ROTAX 582 UL Carb Adapter

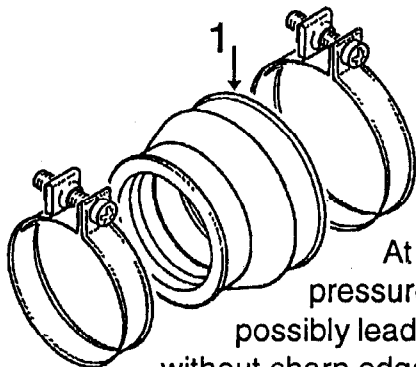
Up to engine no. 4,016.083 a carb adapter **with sharp edges** was supplied: After investigating into details a modified adapter (Rotax part no. 867 695) with rounded outlines was fitted, beginning with engine no. 4,016.084. Owing to the roundings, the risk of cracking was reduced essentially. To attach these two types of adapters two clamps of different sizes are needed:

Because of the occasional reclamation from customers a carb adapter with 1 mm bigger wall thickness was fitted, starting with engine no. 4,171.840.
New ROTAX part no. 867 696.

◆ NOTE: Find ROTAX part no. ❶ on backface of carb adapter.

ROTAX part no. 851 060 clamp 60
951 510 clamp 52

This change, made for safety's sake, makes two new clamps necessary:
ROTAX part no. 851 065 clamp 62
951 400 clamp 53
